**METROPOLITAN GOVERNMENT OF NASHVILLE AND DAVIDSON COUNTY**

**STAFF RECOMMENDATION**  
**1300 Elmwood Avenue**  
**April 18, 2018**

**Application:** New construction—outbuilding  
**District:** Belmont - Hillsboro Neighborhood Conservation Zoning Overlay  
**Council District:** 18  
**Map and Parcel Number:** 10513010600  
**Applicant:** Matthew T. Schutz  
**Project Lead:** Jenny Warren, jenny.warren@nashville.gov

Figure 1: 1300 Elmwood Ave

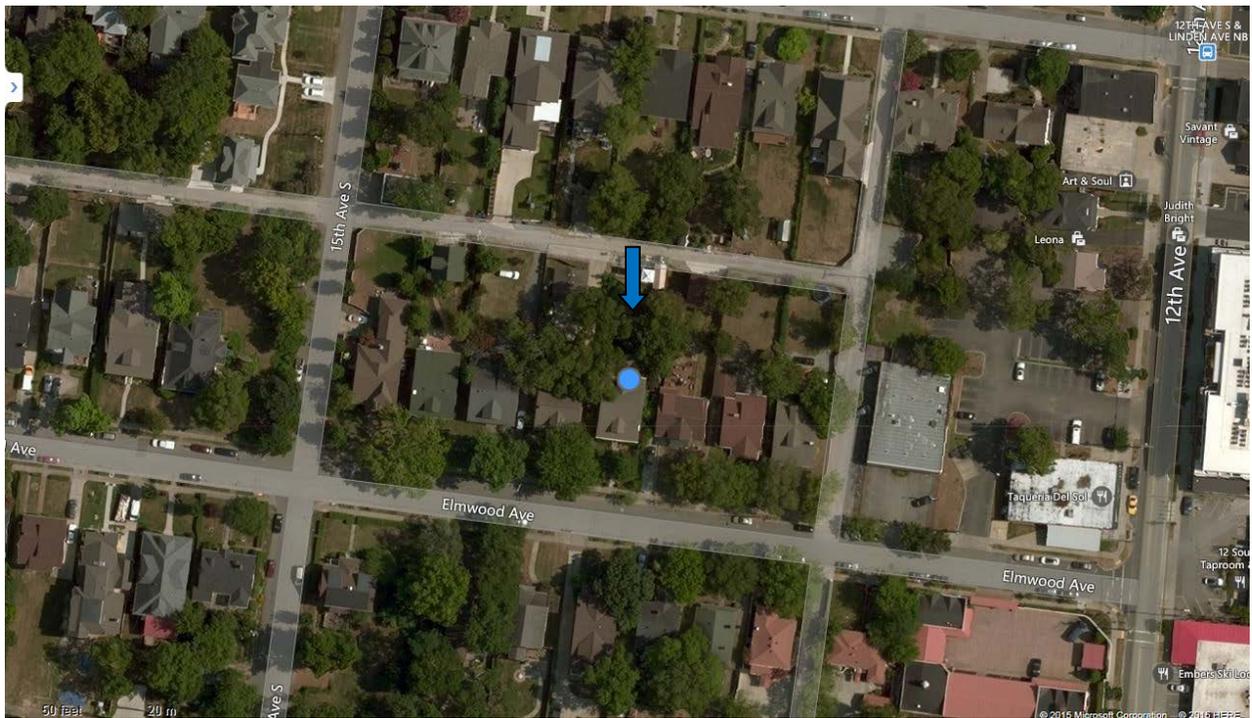
**Background:** 1300 Elmwood Avenue is a c. 1930 bungalow that contributes to the historic character of the Belmont-Hillsboro Neighborhood Conservation Zoning Overlay (Figure 1). Two previous permits have been issued for outbuildings at this address, one in September of 2015 and one in January of 2016, though neither of those proposed structures was constructed. This application presents a new design.
